Access Compliance Report

Public Rights-of-Way

(Curb Ramps)

Intersection ID: 6113	Main Street: PURSLANE_CT	Cross Street: YARROW_RD	Location:	W
ADA ID: DFA0CFBDD895	Ramp Type: Perp	Initial Pass/Fail: Fail	Overall Compliance: No	Severity Score: 10

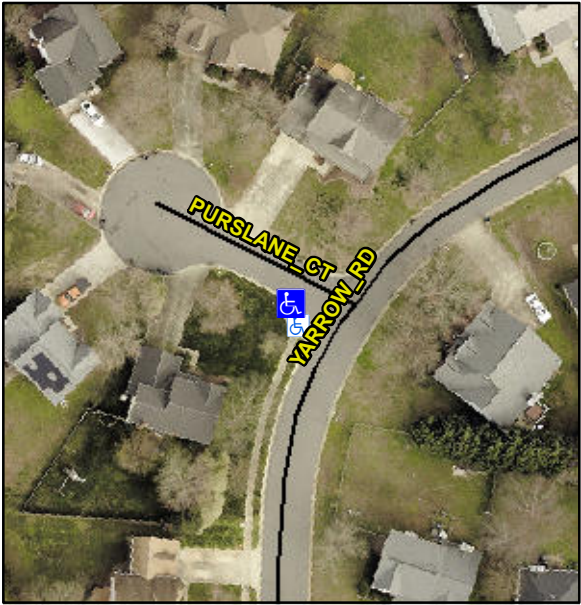
Codes/Mitigation Info/Possible Solution			Field Measurements/Component Compliance		
	Possible Solutions:		Compliance	Description	Data
	Remove & Replace Entire Ramp.		Yes	Ramp Length (in)	46.0
			No	Ramp Width (in)	47.0
			N/A	Flare Type LT	N/A
			N/A	Flare Slope LT (%)	N/A
			N/A	Flare Traversable LT?	N/A
			N/A	Landing Length (in)	N/A
			N/A	Landing Width (in)	N/A
			N/A	Landing Slope (%)	N/A
			N/A	Landing X Slope (%)	N/A
<p>Surveyor Notes:</p> <p>N/A</p> <p>PROW/ADA:</p> <p>Not Found, R304.5.1, R304.5.3</p>			N/A	Flare Type RT	N/A
			N/A	Flare Slope RT (%)	N/A
			N/A	Flare Traversable RT?	N/A
			N/A	DWS Provided?	N/A
			N/A	DWS Contrast?	N/A
			N/A	DWS Length (in)	N/A
			N/A	DWS Full Width?	N/A
			N/A	DWS Offset (in)	N/A
			N/A	Gutter Ponding?	N/A
			N/A	Gutter Lip Ht (in)	1.0
			No	Painted X Walk1?	N/A
				X Walk 1 Direction	To NE
			N/A	X Walk 1 Width (in)	N/A
				X Walk 1 Slope (%)	0.7
				X Walk 1 X Slope (%)	4.0
